Re: Third Submission Review – Murphy Creek / Harvest Ridge PA - Site Plan and Plat
Application Number: **DA-1250-54**
Case Numbers: **1995-2002-10; 2021-4019-00; 2021-3039-00**

Third Submission Review

Figure 4.2-3: Motor Courts

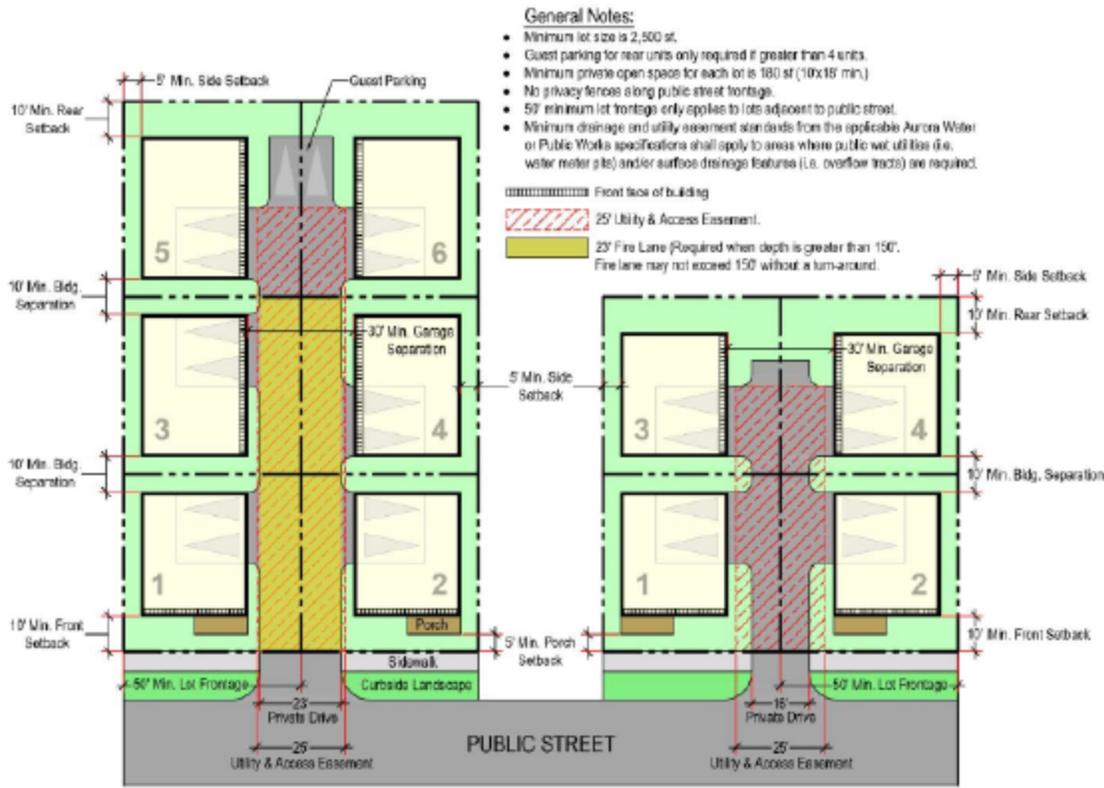
3H. Repeat Comment since 1st Review: The lot lines should be split down the middle of the internal "drive" for Motor Court Products. This comment has been given since the first review, and the response is not sufficient. Meeting and gaining approval from Real Property does not exclude the site plan from the code. The code has a shared internal drive so utilities can be in the tract allowing for trees and landscape in the front yards of the motor courts. The utility easement outside the tract triggers an adjustment and hearing. Currently the utility easement is 35' which is larger than most roads. Why is this necessary?

3J.
